CITY OF NEWPORT BEACH
ZONING ADMINISTRATOR STAFF REPORT
December 23, 2013
Agenda Item No. 2:

SUBJECT: Bari Studio Minor Use Permit - (PA2013-230)
2125 San Joaquin
- Minor Use Permit No. UP2013-026

A RESOLUTION OF THE ZONING ADMINISTRATOR OF THE CITY OF NEWPORT BEACH APPROVING MINOR USE PERMIT NO. UP2013-026 FOR A LARGE-SCALE HEALTH AND FITNESS FACILITY (BARI STUDIO) LOCATED AT 2125 SAN JOAQUIN HILLS ROAD (PA2013-230)

PARKING SPACE ANALISYS

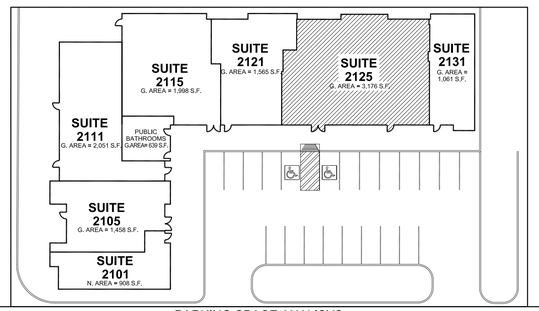
7. The suite numbers shown on the first sheet of the "Tenant Improvement Drawings" in Attachment ZA 6, and repeated in the "Parking Summary" on handwritten page 20, differ substantially from the tenant addresses shown on the City's GIS map (including not only a different arrangement of the numbers within the building, but a "2115" where the GIS shows "2123"). Do the GIS designations need to be corrected?

SITE PLAN

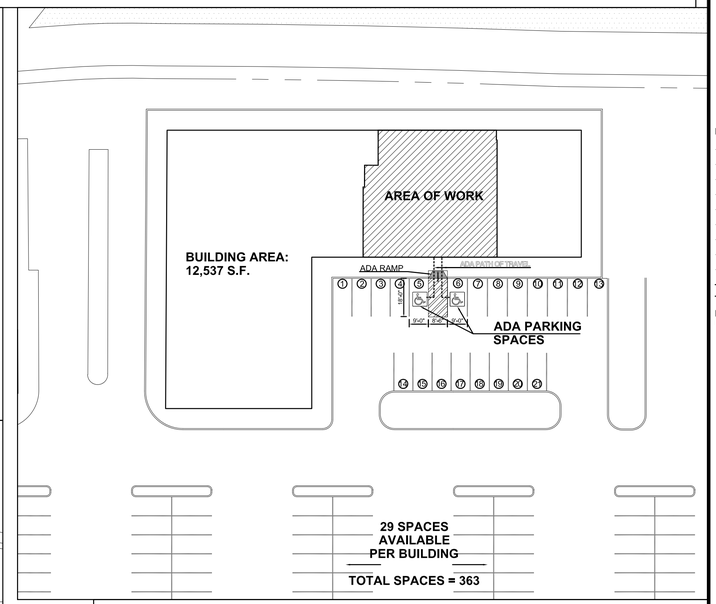
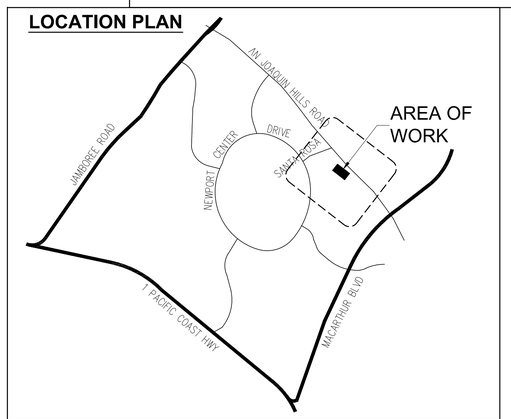
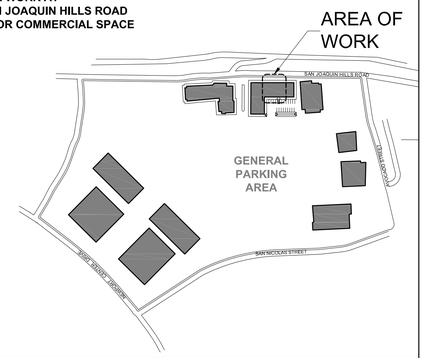
1. Facts in Support of Finding C.3 says the project "*is oriented towards the parking lot away from the residential uses.*" The orientation of the project plans provided in Attachment ZA 6 is difficult to follow, and the statement may be correct with respect to the entry areas (which I think are shown to the left) but I have the impression that Exercise Studios A & B are designed to have windows (on the right) looking out over San Joaquin Hills Road towards Big Canyon. It is unclear if they are large enough to be readily visible from there.
